200 WEST HIGHLAND

Photo reference and corrected native daylight study

Revision 03 / Cycles daylight

Owner-supplied photo-02

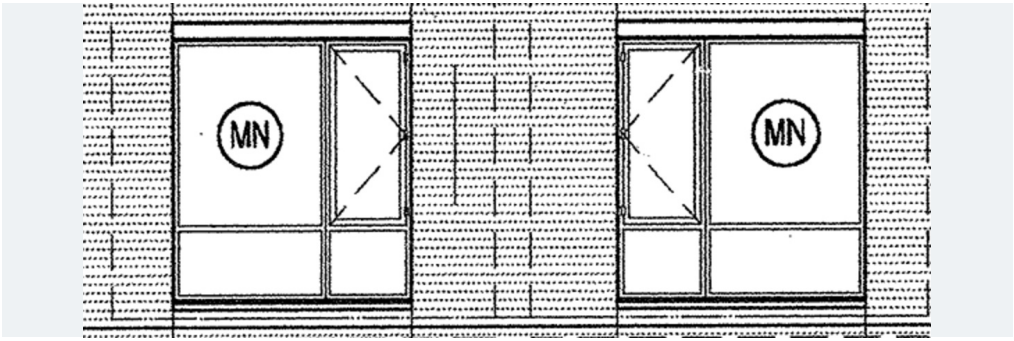
Geometry correction. Added the missing central brick parapet and pale southwest/southeast terrace cornices. Corrected coping tops and two wall headers at the inherited roof-level split. Mirrored the eight MN window dividers to follow the elevation pattern.

Recorded source picks / provisional terrace heights and pane proportions

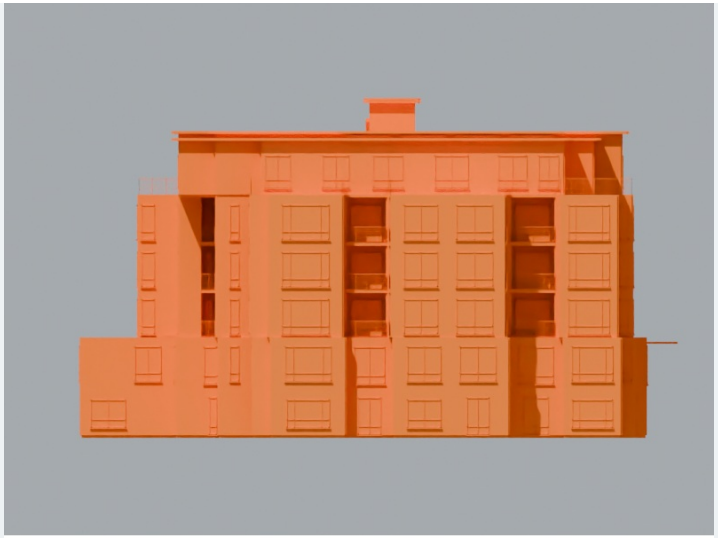
Modeled heights above R5. Central brick: 28 in; southwest cornice: 26 in; southeast corner: 30 in. Manual source-pick allowance: about +/-3 in. Coping profiles and return extents remain assumed.

Mirrored MN windows. Internal bars are placed at about 65% and 35% of opening width from west to east, repeated on R1-R4. Ratios are provisional, about +/-0.03. Only each internal vertical bar moves; perimeter frames and horizontal rails stay fixed.

South elevation / fixed-camera geometry comparison

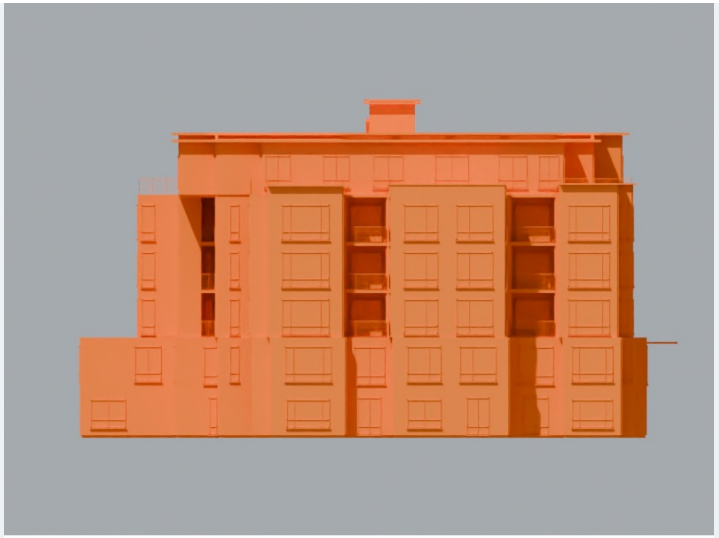
The source panel is fitted independently for qualitative comparison. The before/after model panels share the same orthographic scale and camera. Orange denotes complete components with assumed geometry. Roof/terrace changes follow the recorded datum and scan picks; no edge-agreement or as-built claim is made.
